Intersection ID: 52582	Main Street: NOBLES_AV	Cross Street: N/A	Location:	N
ADA ID: 14E187CDC2A9	Ramp Type: Perp	Initial Pass/Fail: Fail	Overall Compliance: No	Severity Score: 13.75

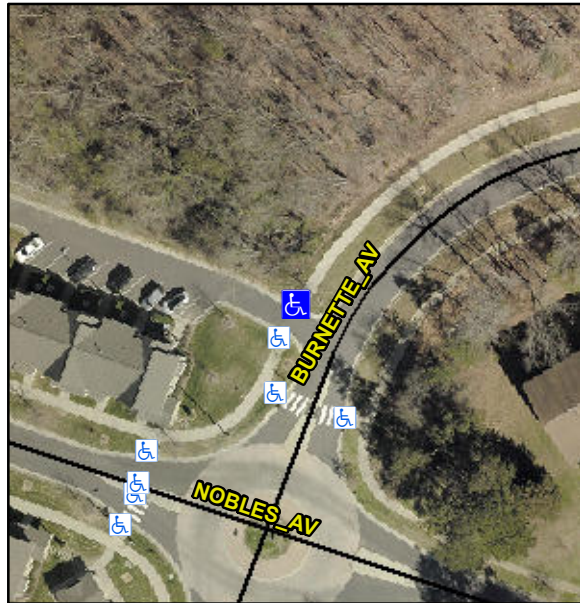
**Not Found, R304.2.2, R304.5.3**

Compliance	Description	Data	Compliance	Description	Data
N/A	Ramp Length (in)	74.0	No	Ramp Slope (%)	8.4
Yes	Ramp Width (in)	70.0	No	Ramp XSlope (%)	3.1
N/A	Flare Type LT	N/A	N/A	Flare Type RT	N/A
N/A	Flare Slope LT (%)	N/A	N/A	Flare Slope RT (%)	N/A
N/A	Flare Traversable LT?	N/A	N/A	Flare Traversable RT?	N/A
N/A	Landing Length (in)	N/A	N/A	DWS Provided?	N/A
N/A	Landing Width (in)	N/A	N/A	DWS Contrast?	N/A
N/A	Landing Slope (%)	N/A	N/A	DWS Length (in)	N/A
N/A	Landing X Slope (%)	N/A	N/A	DWS Full Width?	N/A
N/A	Landing Curb? (Y/N)	N/A	N/A	DWS Offset (in)	N/A
N/A	Shared Landing?	N/A			
N/A	Gutter Ponding?	N/A	N/A	Gutter Slope (%)	N/A
N/A	Gutter Lip Ht (in)	N/A	N/A	Gutter X Slope (%)	N/A
N/A	Painted X Walk1?	No	N/A	Painted X Walk2?	N/A
	X Walk 1 Direction	To SW		X Walk 2 Direction	N/A
N/A	X Walk 1 Width (in)	N/A	N/A	X Walk 2 Width (in)	N/A
	X Walk 1 Slope (%)	2.1		X Walk 2 Slope (%)	N/A
	X Walk 1 X Slope (%)	2.3		X Walk 2 X Slope (%)	N/A

### Remove & Replace Entire Ramp.
